**Consumers
Power
Company**

February 20, 1975

Re: Docket 50-255
License DPR-20
Palisades Plant

RESPONSES TO USNRC
Request of February 4, 1975
for Additional Information

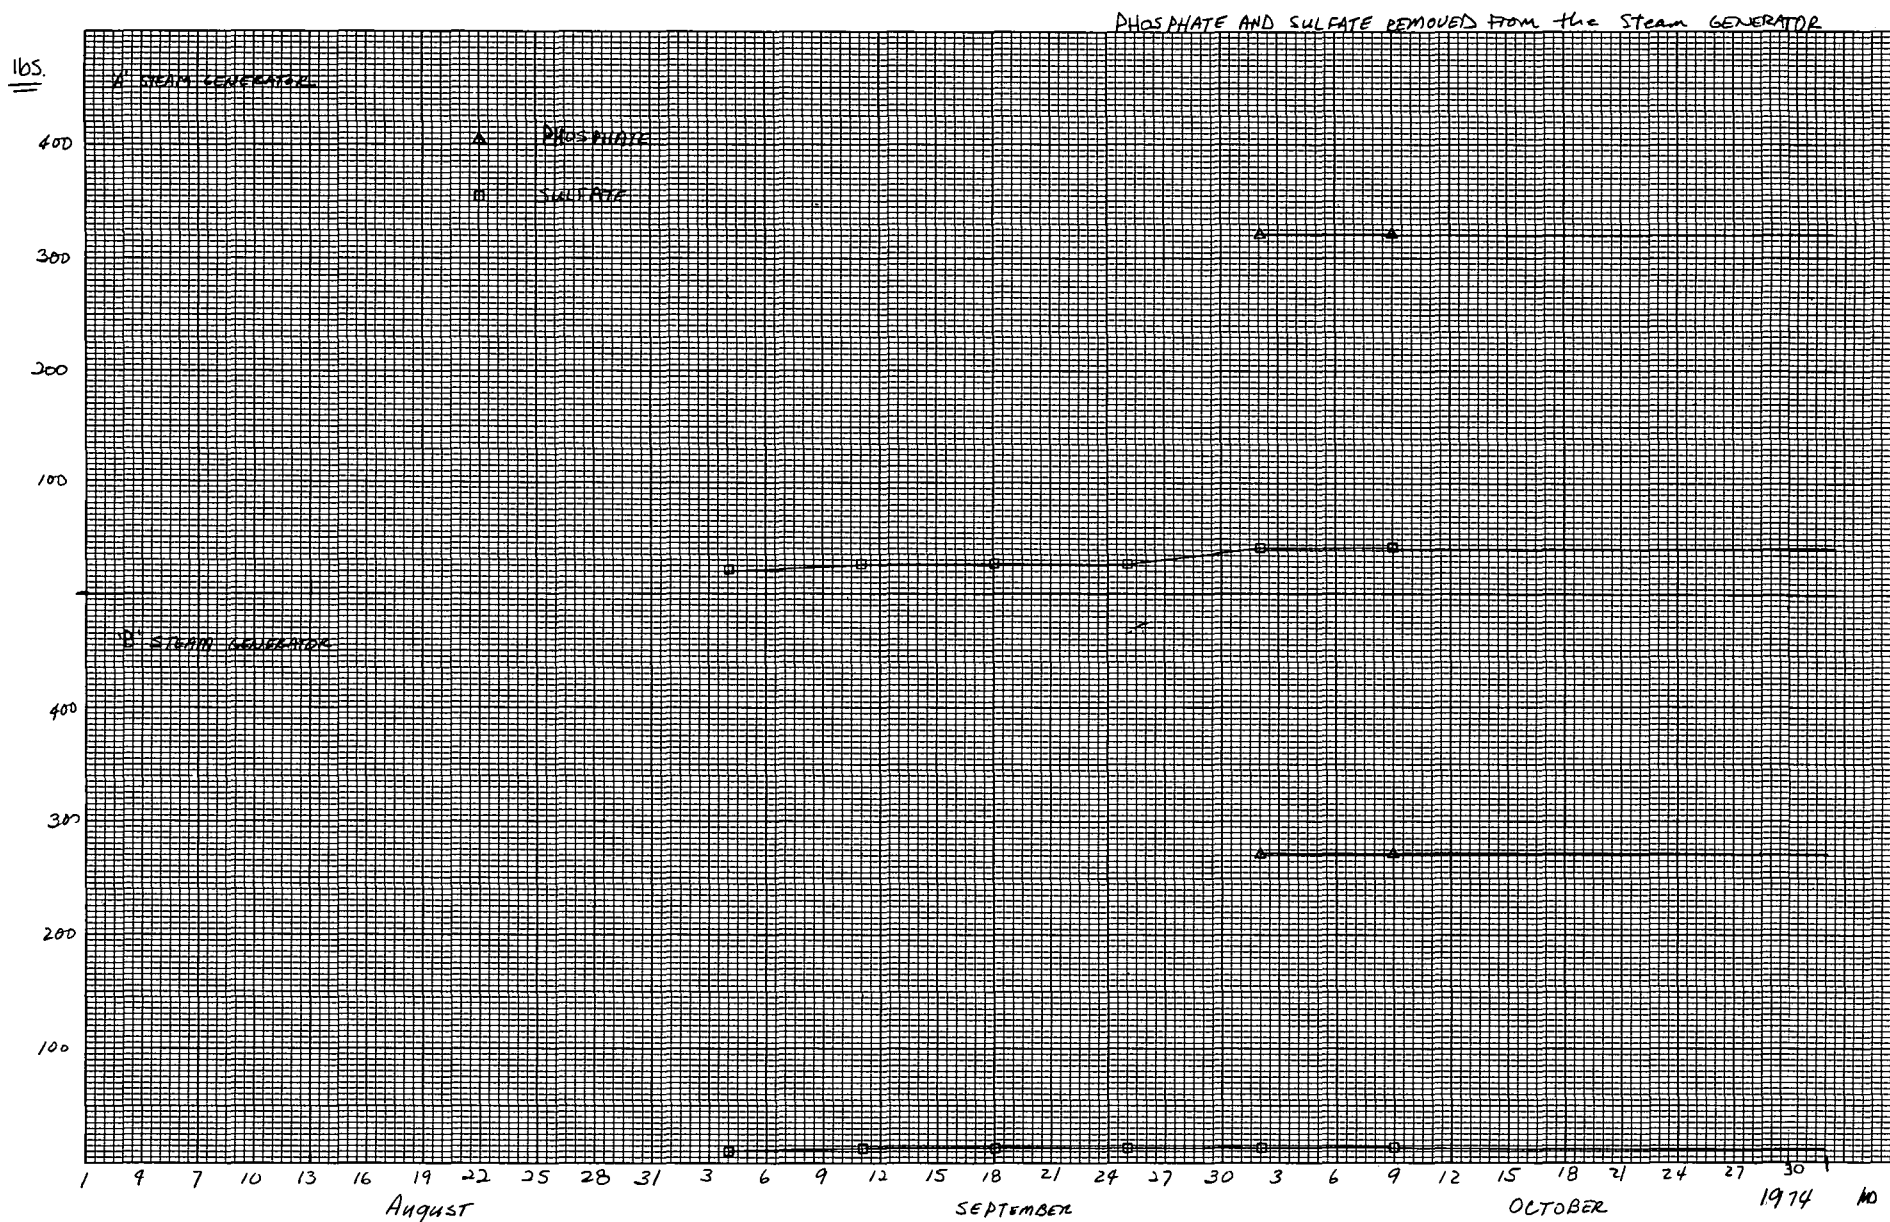
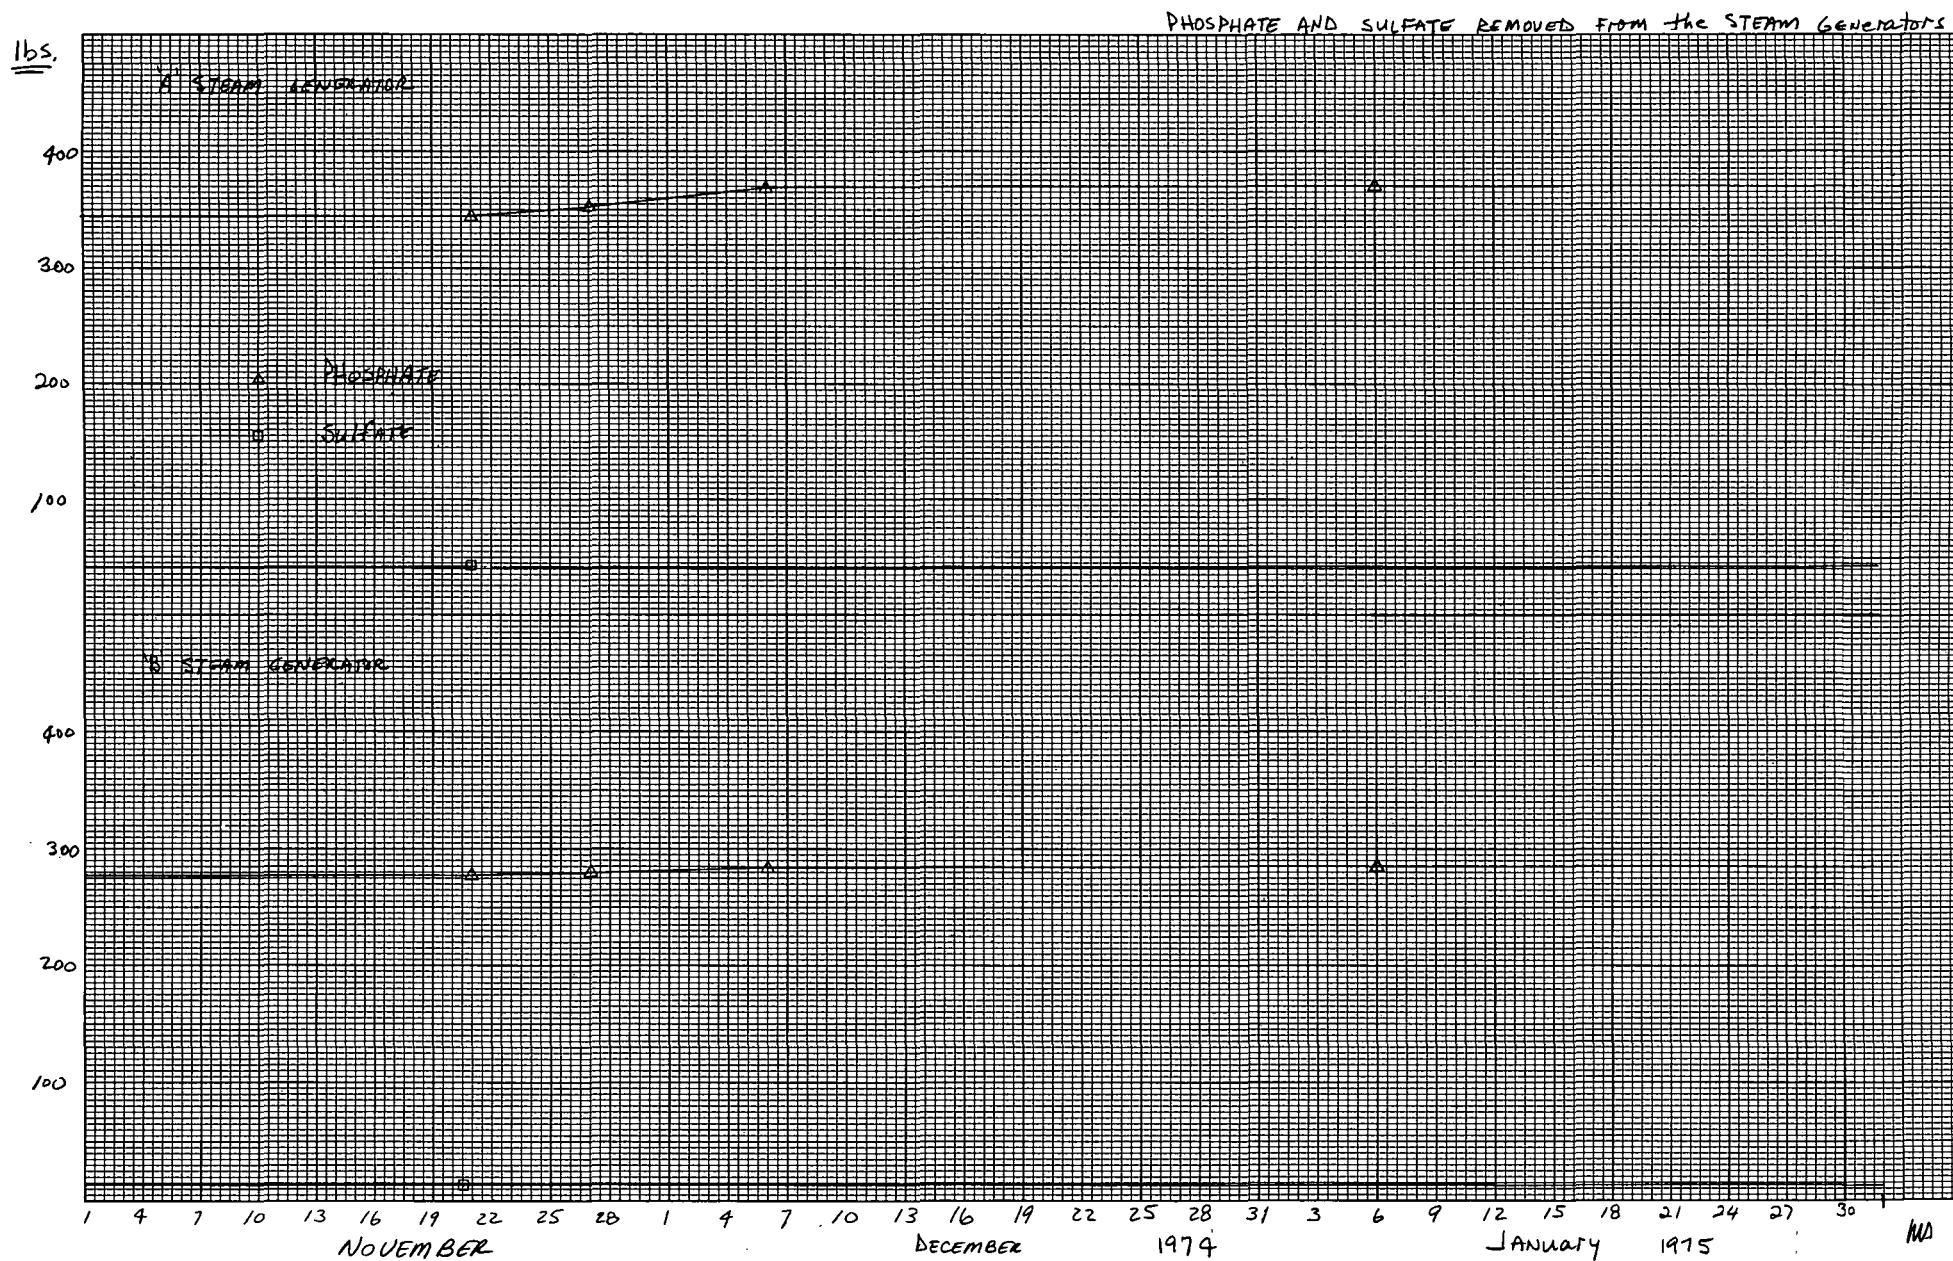
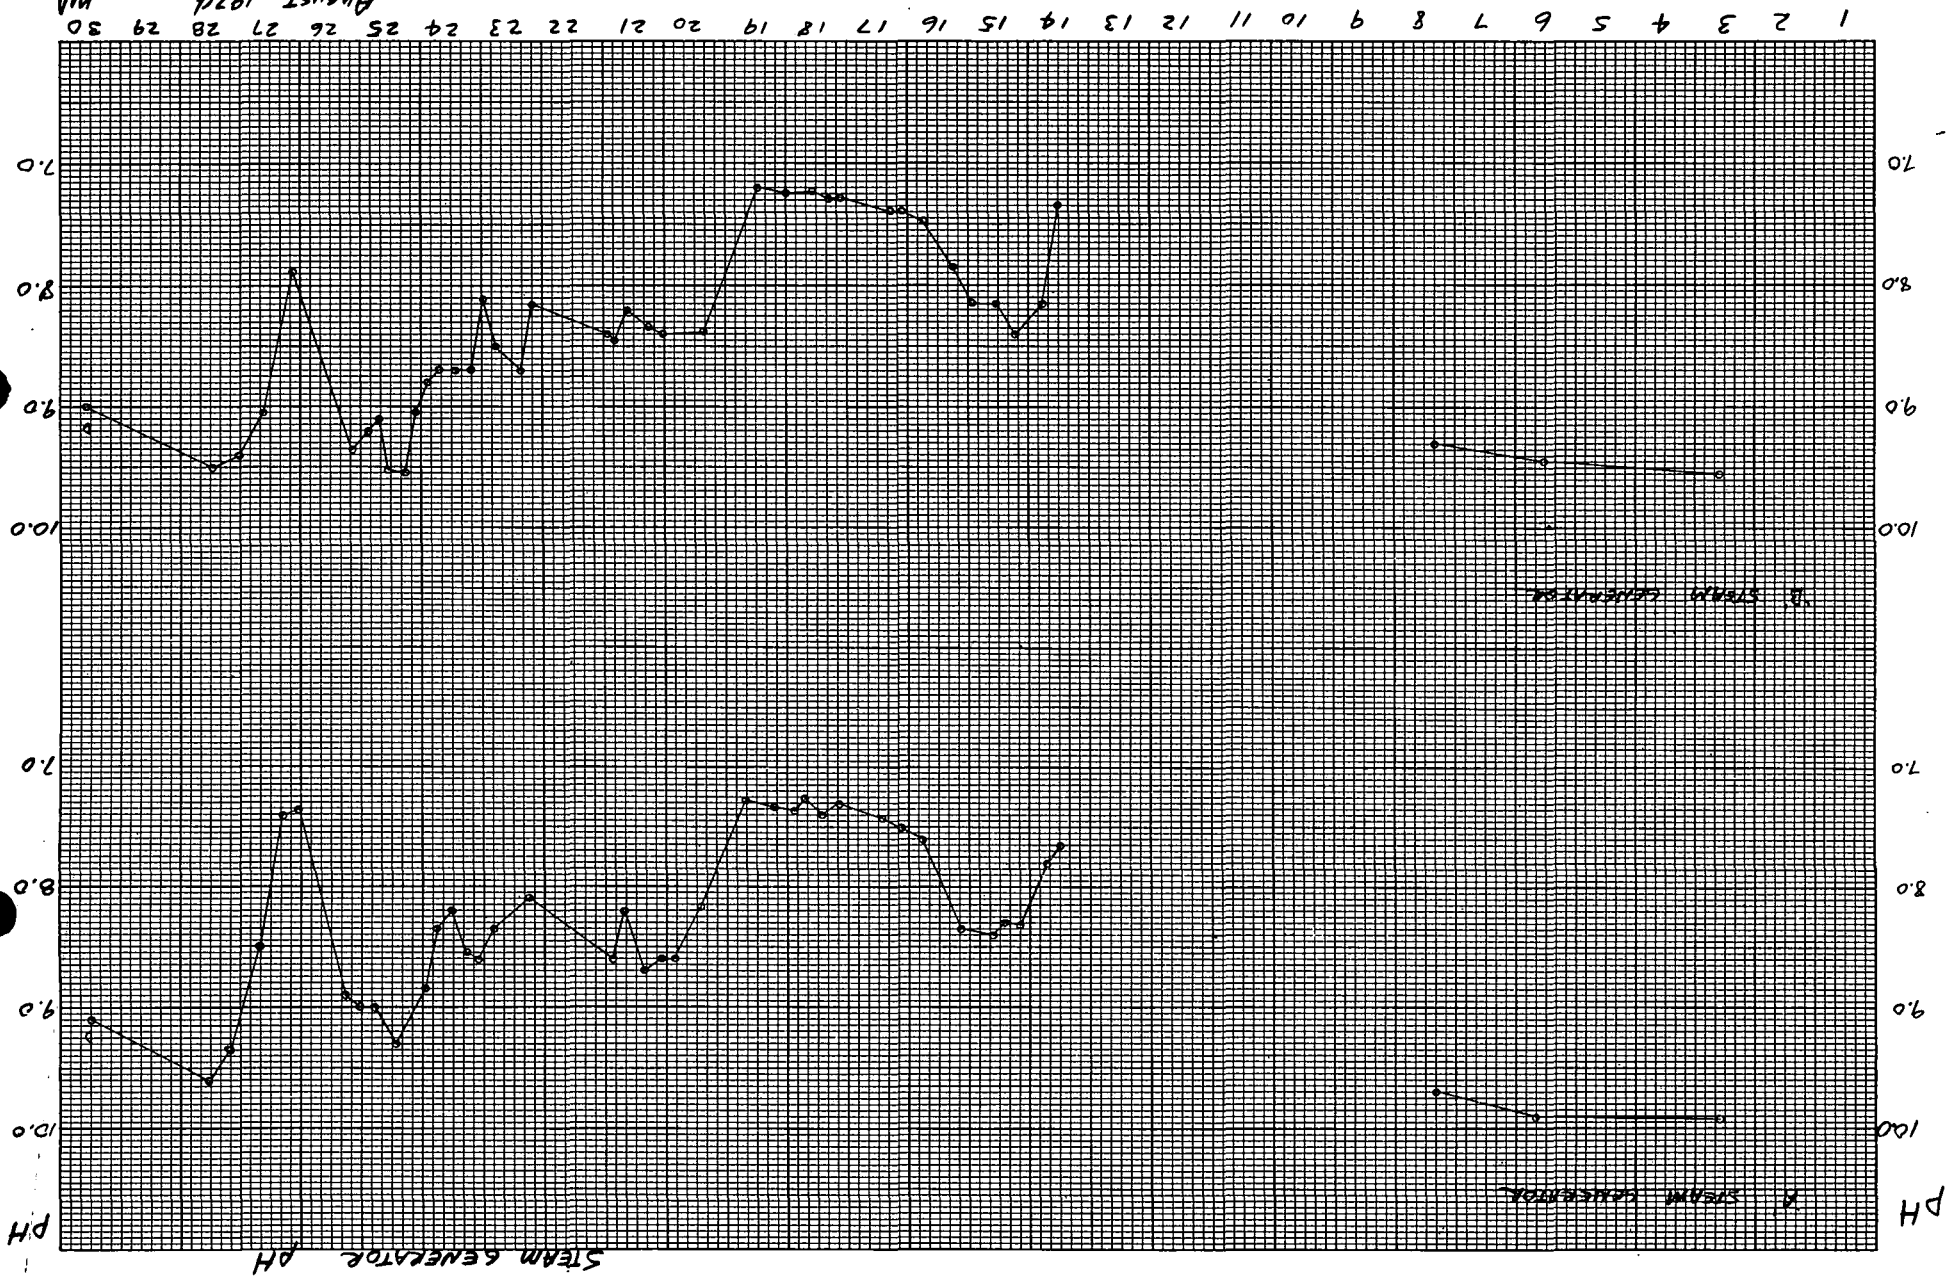
Question 6

"Provide a graph or plot showing the following as a function of time for both steam generators from the onset of isothermal flushing operations to the present:

- a. Phosphate and sulfate concentration,
- b. pH and,
- c. pounds of phosphate and sulfate removed.

The attached graphs, supplemented by the notes listed below, are provided in response to this request.

Notes

1. The letter "D" on several of the graphs indicates a sample (generally a composite) taken during a generator drain.

2. The first accounting of total PO_4 and SO_4 removed from the generators took place in early September; however, due to the error noted late in September with the PO_4 analysis, the total PO_4 removed starts in October. Quite a lot of work would be required to go back and add up the results for the missing four data points (September) and, therefore, it was not done.

3. Due to circulating water leakage (high in SO_4) after October 1, 1974, the pounds of sulfate removed from the generators were no longer calculated. It would be impossible to determine whether we are removing sulfate from the "old sludge" or from the "new sludge" caused by condenser leakage.
